Waterwood MASTER PLAN

INFORMATION SHEET FOR
PRELIMENARY OVERALL AREA DEVELOPMENT PLAN

FILE NO. #310 Waterwood POADP
P.O.A.D.P. NAME

Re: Waterwood POADP
Plan #310

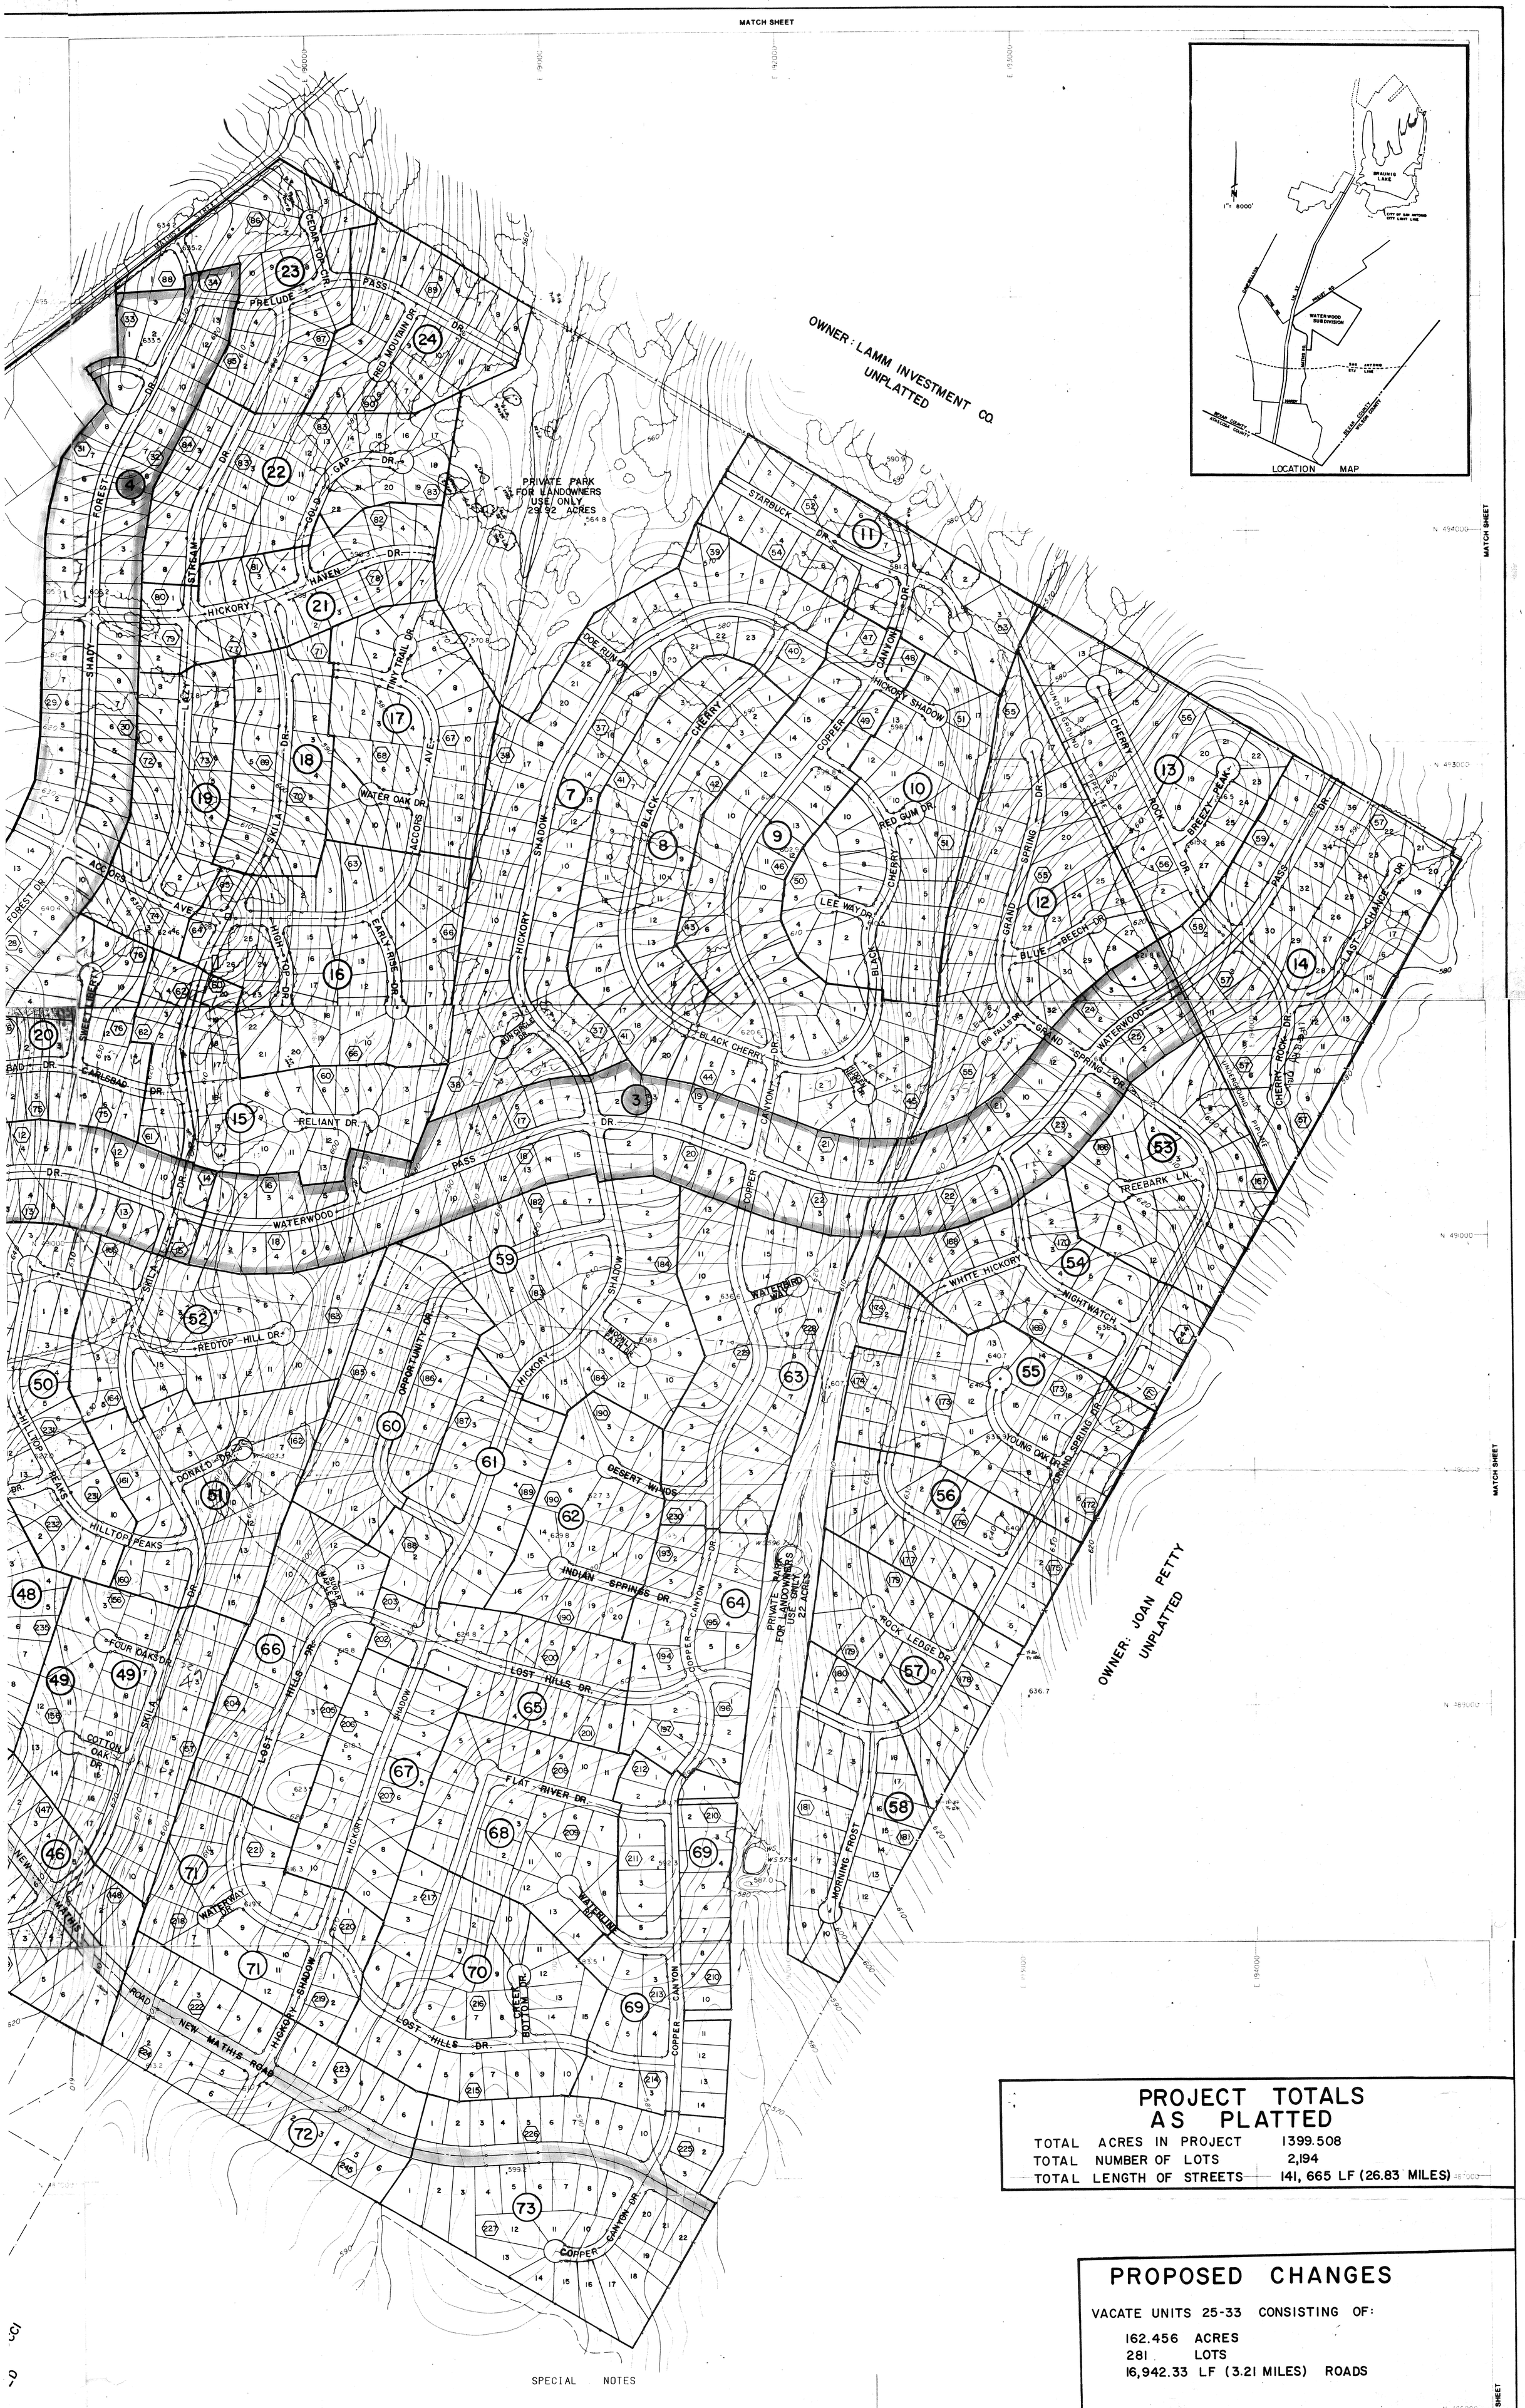
The Development Review Committee reviewed your plan of Waterwood and assigned file #310 for future reference. The area proposed to be resubdivided includes a cul-de-sac street in access of 2000' ft. in length and a local type street located off of Shady Forest Dr. dead ends onto this site. Staff recommends the long cul-de-sac street either be extended to Priest Rd. or looped around to tie into Shady Forest Dr. The dead end street will require a cul-de-sac upon formal plat filing. The plan will be held in abeyance pending your response.

Specifically, the code requires that you show proposed land uses by location, type and acreage. Row widths of existing adjacent or perimeter streets. The limits of the 100 year flood plain as identified from the most current FEMA maps. Location map indicating the location and distance to adjoining streets and at least two (2) major thoroughfares. The name and address of the developher. Finally, identify existing or proposed collector, arterial and or local type B streets and their relationship to any major thoroughfare.
